**River Valley Mechanized Access  
Environmental Impact Assessment**

**Final Report**

**Re: GB15-42 – River Valley Mechanized Access - FINAL Environmental Impact Assessment and Site Location Study Reports**

**City of Edmonton Bylaw 7188 Review Comments Summary**  
**GB15-42 - River Valley Mechanized Access Site Location Study and**  
**Environmental Impact Assessment –**  
*Addendum to the Environmental Impact Assessment and Site Location Study (December 2015)*

# Figure 2.1a

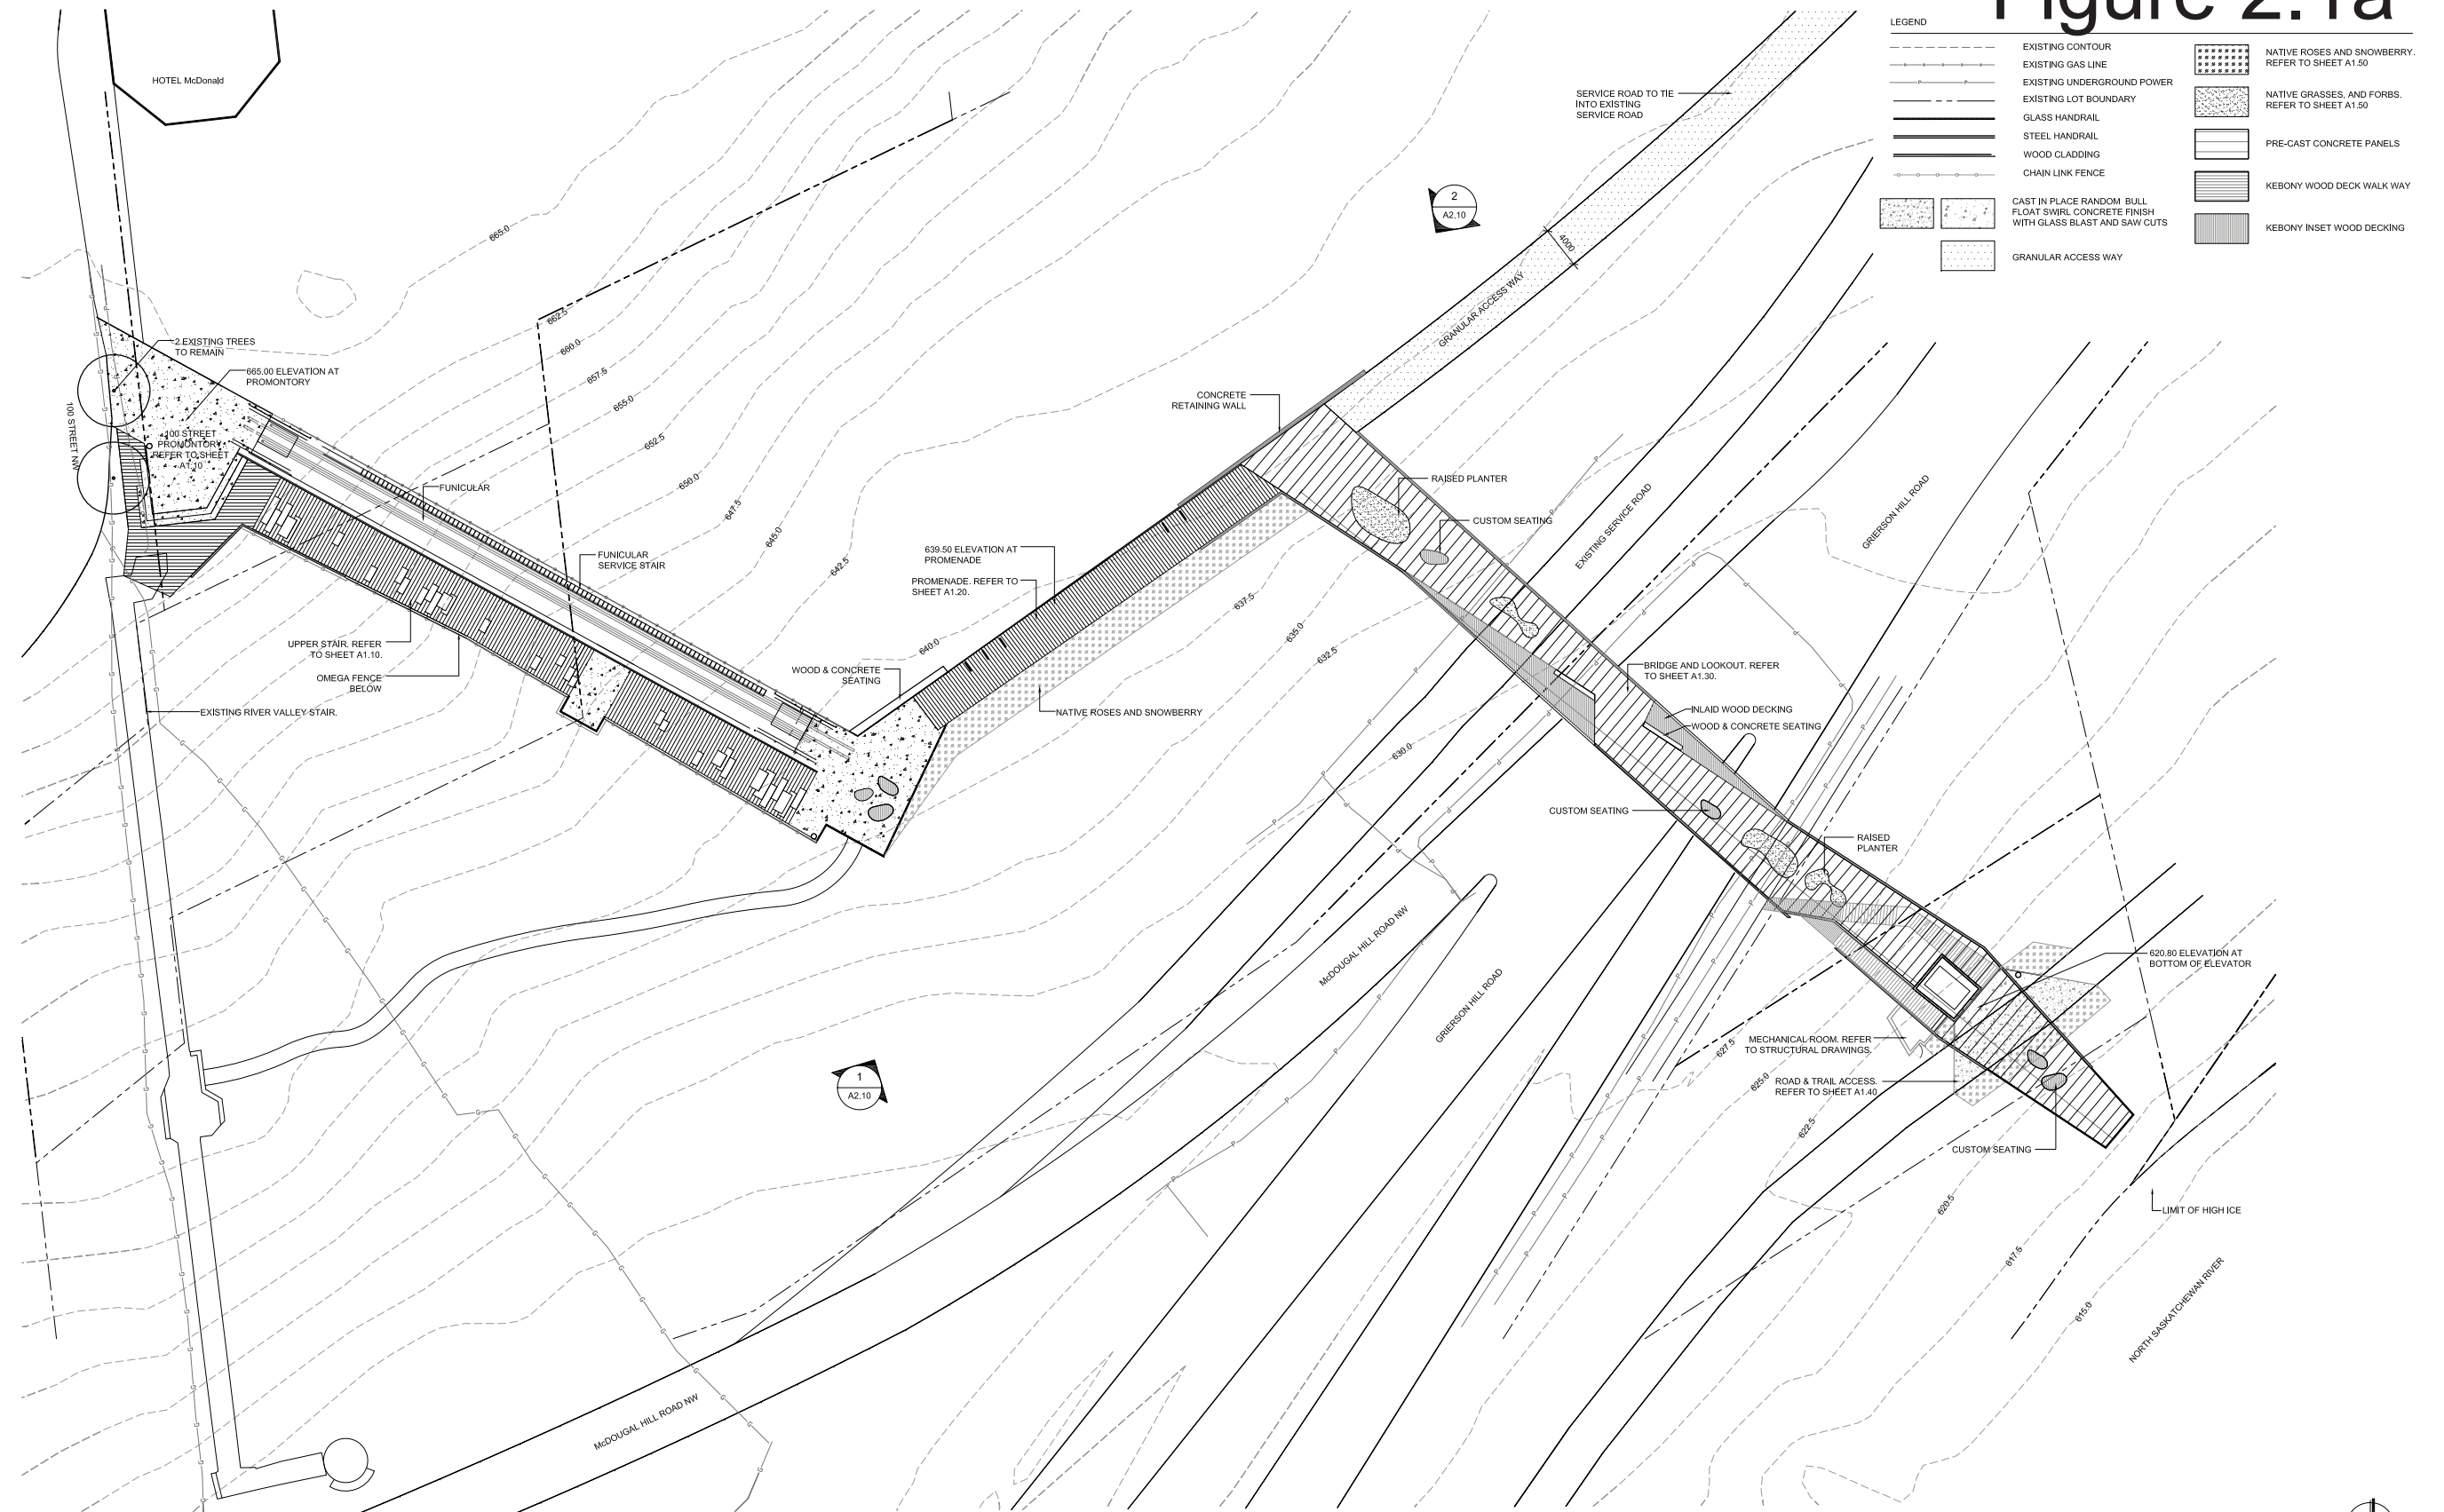
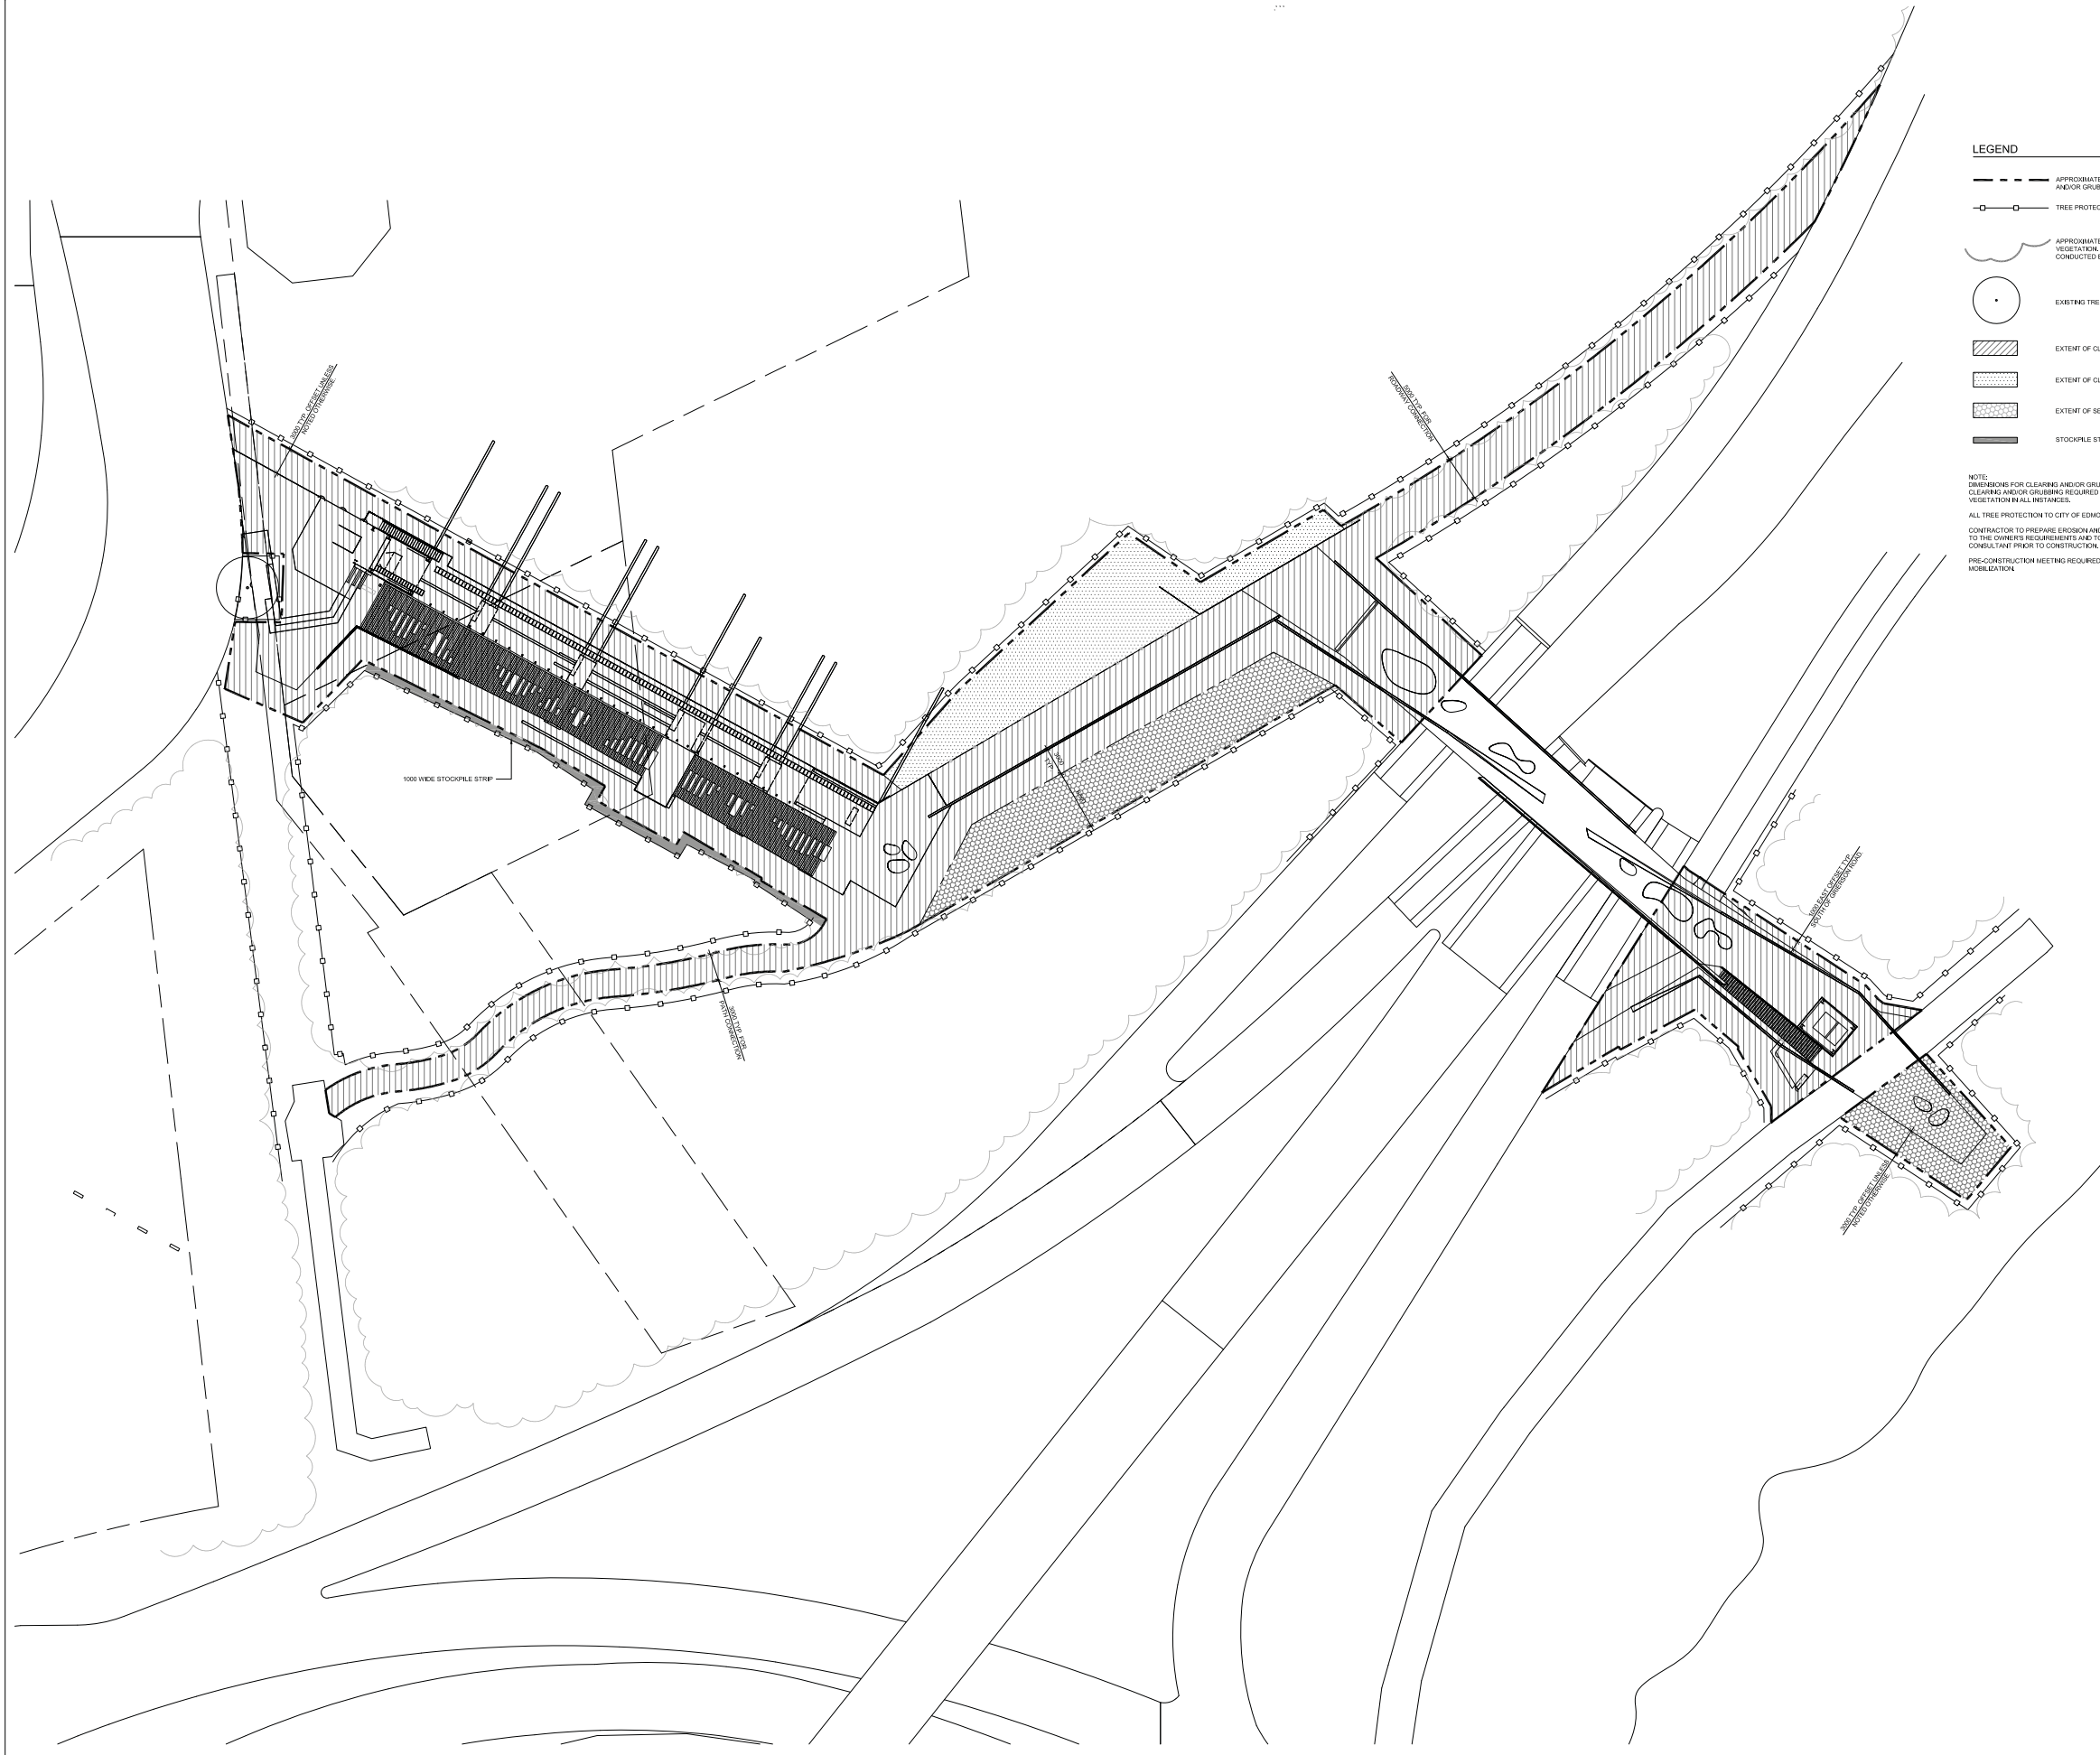
4. Discrepancy between text and illustrations pertaining to width of proposed service access road. Text states this item will be 3.5m and the associated drawings identify it as 4.0m. Please make changes to ensure consistency.	<ul style="list-style-type: none"> <li>• 3.5 m is the correct width of the proposed roadway (see Appendix A).</li> <li>• Clearing for the road will be up to 5.0 m wide, which was accounted for in the</li> </ul>	Figure 2.1

Review Comment	Response Approach	ESR Report Section Reference
	vegetation impact analysis. <ul style="list-style-type: none"> <li>Figure 2.1 will be revised accordingly in the final EIA.</li> </ul>
